**APPENDIX E**  
**Estimation of Rock Mass Strength Properties and Evaluation of Rock Mass Structure**

**APPENDIX E.1**  
**WSDOT Memorandum Dated April 8, 2009**

SUBJECT: I-90 Snoqualmie Pass East – Hyak to Keechelus Dam  
Snowshed shaft foundations

## Snowshed Shaft Foundations: Rock Strength Estimates for DFSAP Analysis - I-90 Snoqualmie Pass East

I-90 Snowshed shafts - low end strength

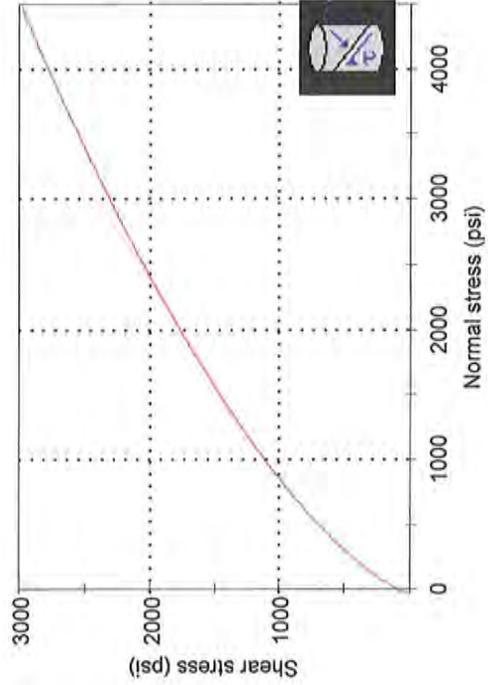
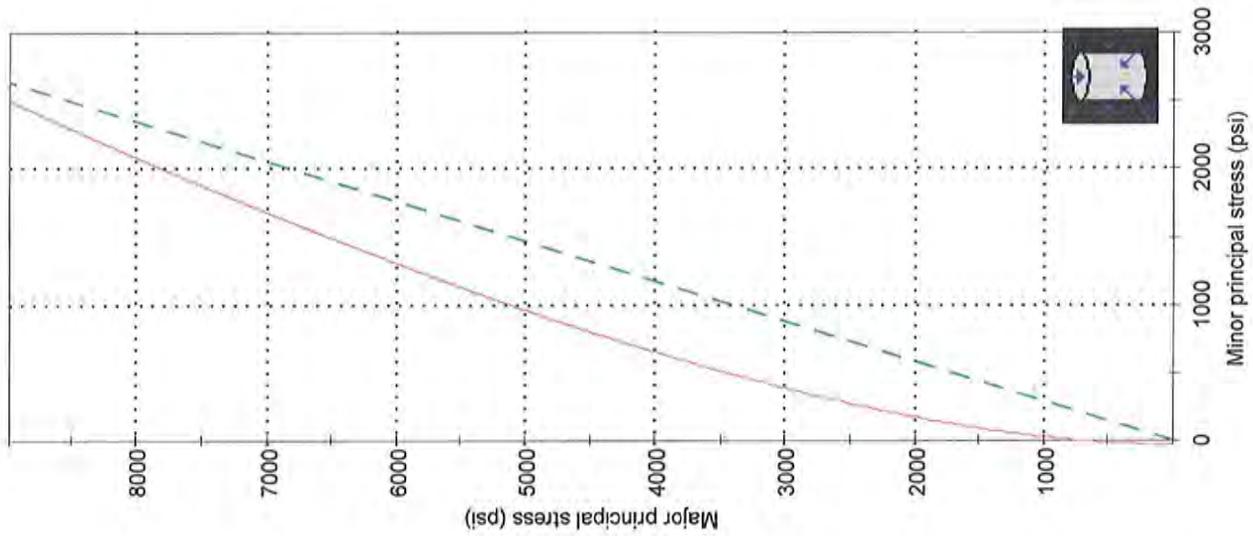
Hoek et al. (2002) present two forms of in situ compressive strength for a fractured rock mass, one referred to as the *uniaxial compressive strength*,  $\sigma_c$ , and the other as the *global rock mass strength*,  $\sigma'_{cm}$ . The latter form is presented (with limited supporting documentation) as a better representation of the overall rock mass behavior, and perhaps more suitable for the complex loading conditions of 3D confinement around a shaft. We computed both forms of rock mass compressive strength for the above-mentioned range of input values (see attached plots), representing a potential lower and upper bound strength:

uniaxial compressive strength ( $\sigma_c$ ) = 600 to 2100 psi

global rock mass strength ( $\sigma'_{cm}$ ) = 1700 to 4400 psi

While Hoek-Brown failure criterion is empirically derived from and is primarily used for excavations, it is the best available estimation for compressive strength of a fractured rock mass. We expect that because the rock is confined by soil overburden and not exposed, the application of Hoek-Brown to this foundation problem is likely to be conservative for the proposed 15-foot embedment into rock. For these reasons, we feel that rock mass compressive strengths between 2000 to 3000 psi would be more appropriate for the design of the shafts.

**Figure 1.**— Available Point Load Test (PLT) results for the Snowshed. WSDOT (2009) UCS test results are also graphed. Note that borings H-02-07 is SSD-002-07, and H-03-07 is SSD-003-07.

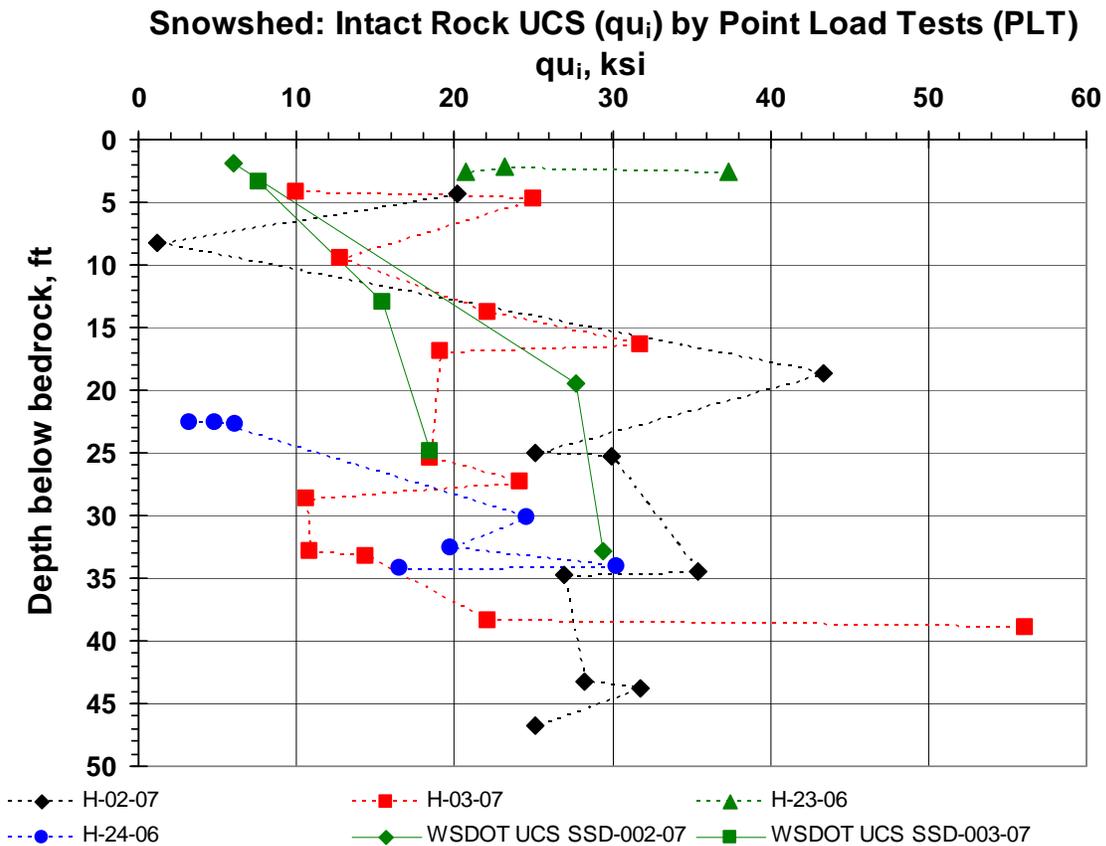
This section updates the TM3 Intact Rock UCS estimate (10.5 ksi) that was based on a statistical analysis and interpretation of available rock PLT data. That data consisted of 33 PLT results on 22 specimens from four borings. Figure 1 graphs the 33 PLT results and WSDOT UCS results as Intact Rock UCS (horizontal axis) against test-specimen depth below the bedrock surface (vertical axis). Figure 2 graphs both the 33 PLT results and the RQD measured at each of the nine borings near the Pier 2 alignment.

**Figure 3.**— Available PLT and WSDOT (2009) UCS test results for the two borings in Tuff. Note that borings H-02-07 is SSD-002-07, and H-03-07 is SSD-003-07.

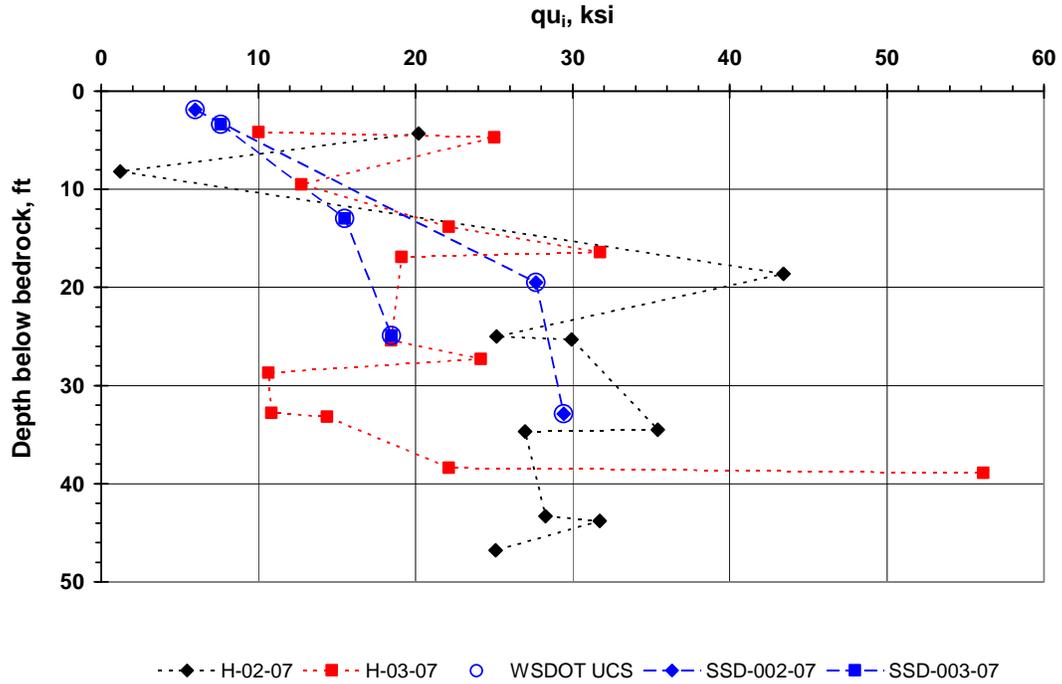
Figure 3 includes only the two borings in Tuff with PLT data and WSDOT UCS measurements. The depth variability and testing gaps apparent in Figure 3 make it impractical to quantify a correlation between PLT and UCS because it is not clear which PLT results, if any, should be paired with the UCS results, which greatly increases the uncertainty of any quantified correlation or trend. However, the average of the six UCS results (17.4 ksi, standard error = 4.0 ksi) and 22 PLT results (21.2 ksi; standard error = 2.3 ksi) were not statistically different at the 95% confidence level (critical  $\alpha > 0.10$ ), supporting the decision to combine available PLT and UCS data in the statistical reliability analysis.

Figure 1  
Snowshed Rock Slope Kinematic Analysis

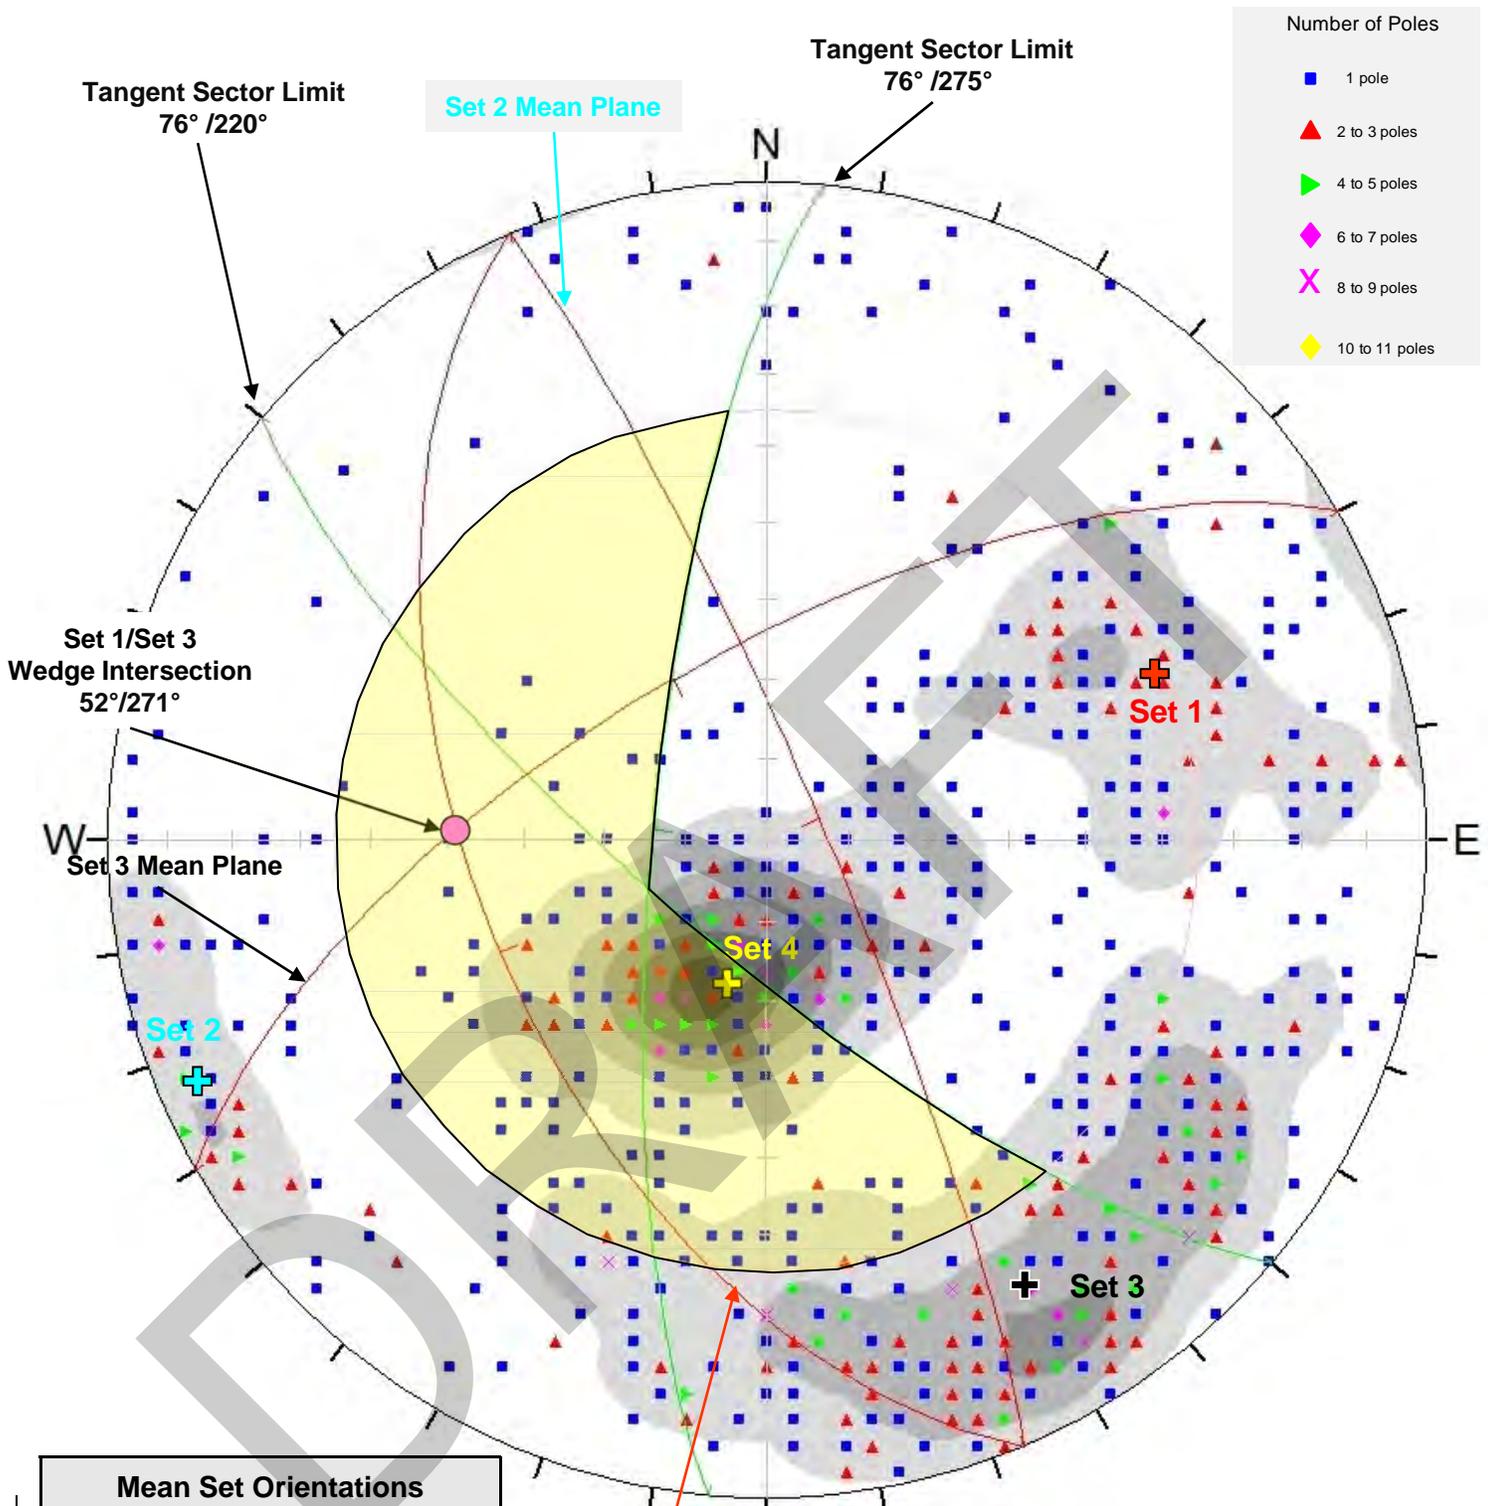
The stereonet in Figure 1 summarizes the data set for the seven boreholes. Poles have been plotted and contoured to accentuate preferred orientations using Rocscience software “DIPS”, Version 5.108. Since the seven boreholes were all drilled vertically, the raw data set has a tendency to under-represent steeply dipping discontinuities. To offset this bias, the stereonet was modified using a standard Terzaghi correction as supplied with the software. Figure 1 indicates three discontinuity sets similar in general orientation to results developed for the rock slope stability

Sets 1 and 1a are inferred to be variants within a common set. The pole and the great circle representations of each mean set orientation are plotted in red on Figure 1. Sets 1, 1a and 3 have westerly dip directions while Set 2 dips to the east. Furthermore, Sets 1 and 1a have strike directions that are parallel to Set 2 but with opposite dip directions.

For design purposes, a maximum inclination of 40° and dip direction range of 225° to 275° were adopted for overall slopes. The great circle representations of these two limiting orientations are plotted in green on Figure 1.

The important observation from the kinematic analysis of Figure 1 is that none of the defined discontinuity sets are oriented so as to give potential to planar or wedge type failures for the orientations of the overall bedrock surface. Furthermore, Sets 1 and 1a are coincident with the range limits for the bedrock surface as demonstrated by the similarity between the respective red and green

**Figure 3**  
**EB Station 1357+46 Detail**

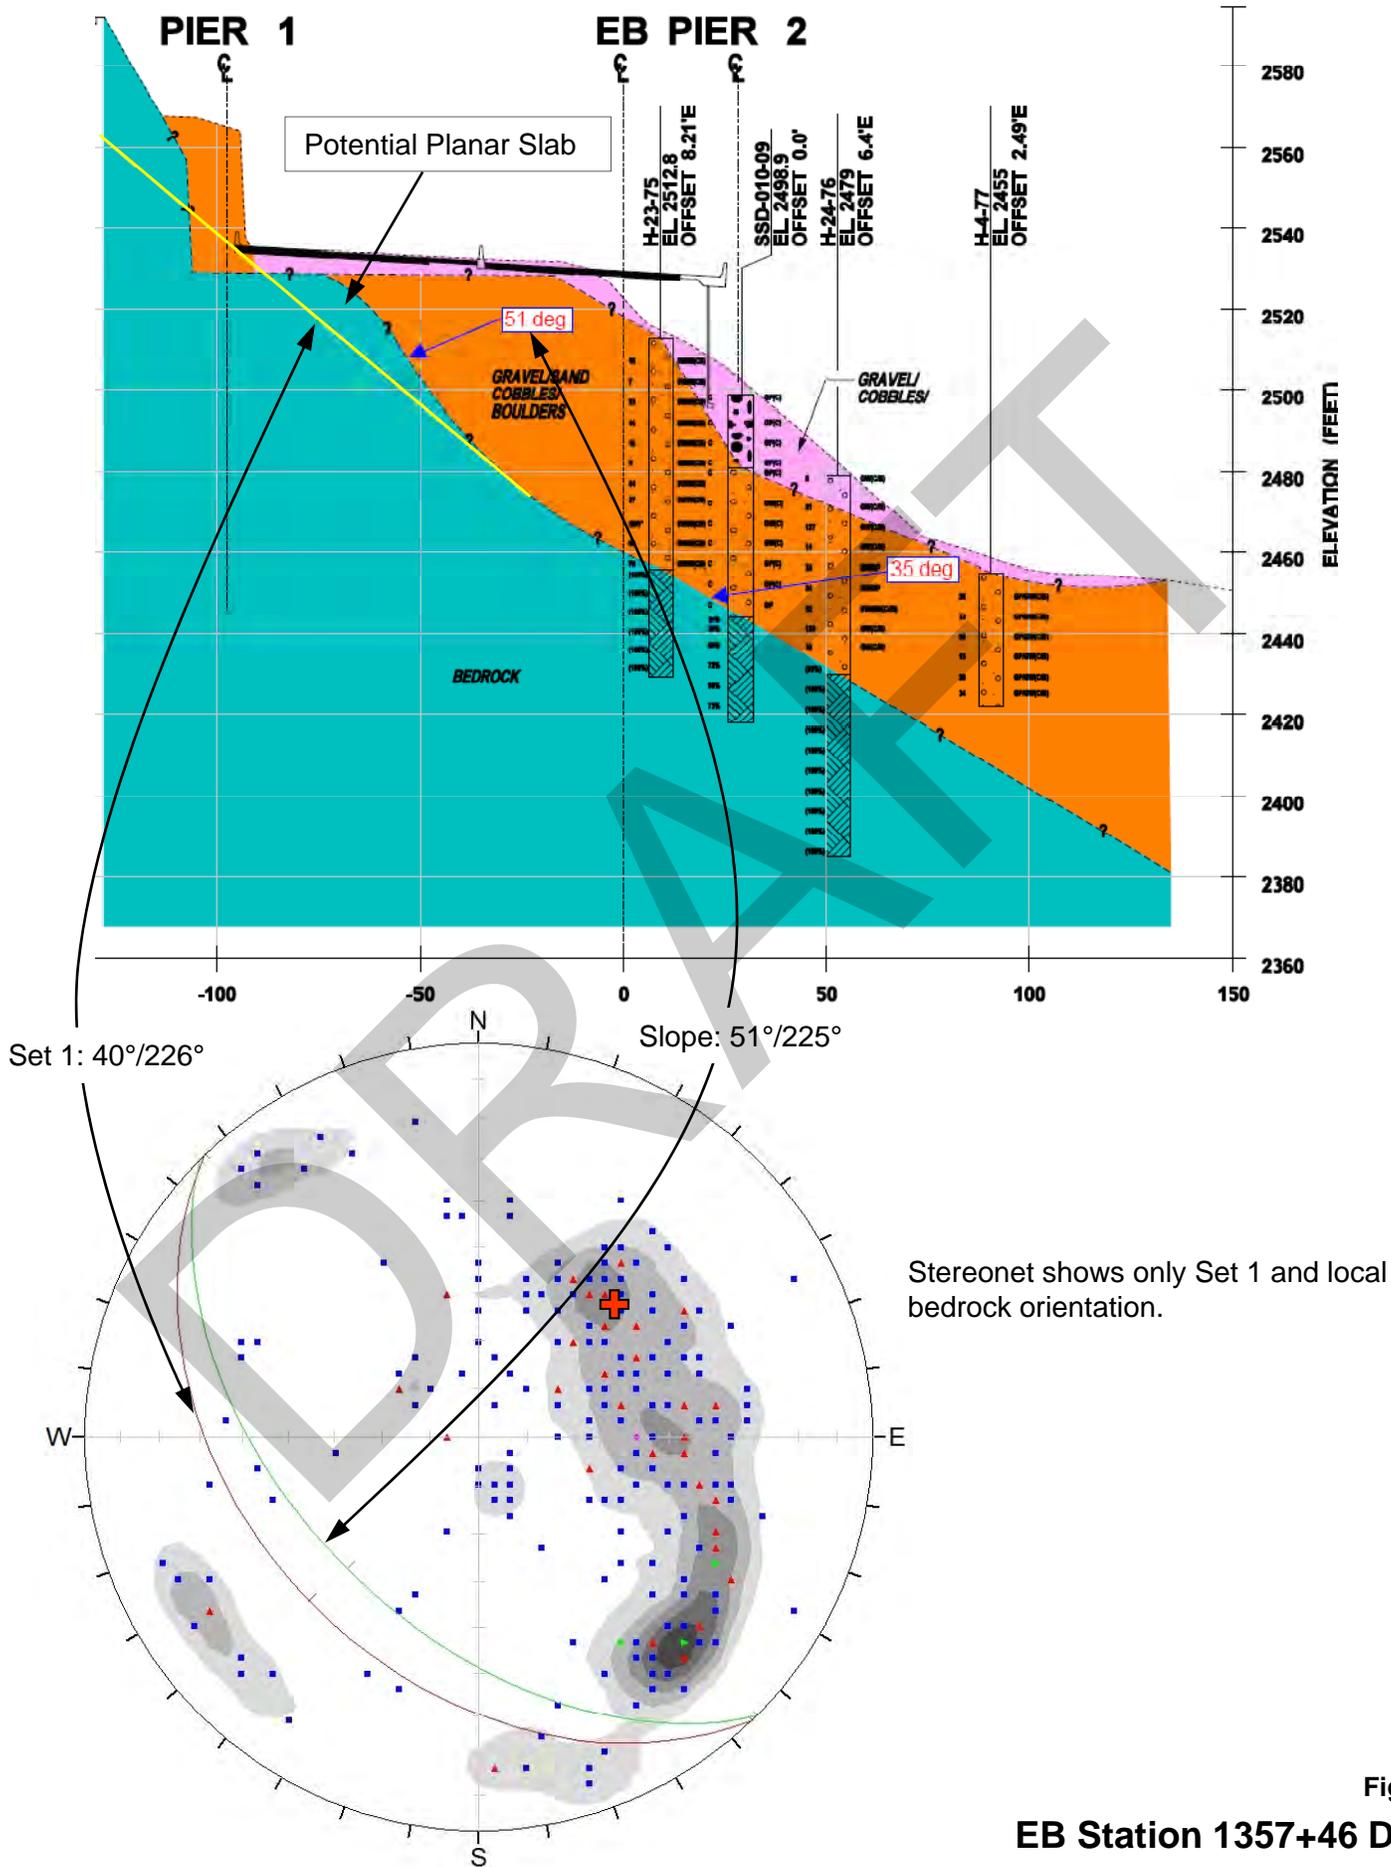
The exception to the above assertion concerning **planar** failure relates to the localized 51° bedrock inclination interpreted at EB Station 1357+46. At this location, Set 1 with a dip of 40° could define a thin slab that daylights on the 51° bedrock surface (Figure 3). A stability assessment of this slab includes consideration of the following:

- The 51° bedrock inclination is an inferred orientation lacking corroboration with site specific exploration. The steep local slope may not be present.
- Stable slopes steeper than 51° are inferred upslope of the SSD and forming the cut slope behind the wall (see Pier 1 area Figure 3).

Potential for localized planar failure was identified at EB 1357+46 due to an inferred steep bedrock surface down slope of Pier 1. Construction observation should be utilized at this location and as a general practice for the entire SSD. Specific recommendations are:

1. Found the entire width of the Pier 1 foundation on bedrock.
2. Correlate the top-of-rock between the Pier 1 excavation and the drill holes for the tiebacks at the shaft and/or for the soil nail wall. If bedrock surfaces steeper than 40° are confirmed, passive reinforcement through the base of Pier 1 should be implemented.
3. If the bedrock surface is steeper than 40°, locate the entire bond zone for the tiebacks at Pier 2 beyond an assumed +40° plane extending upslope from the shaft centerline.
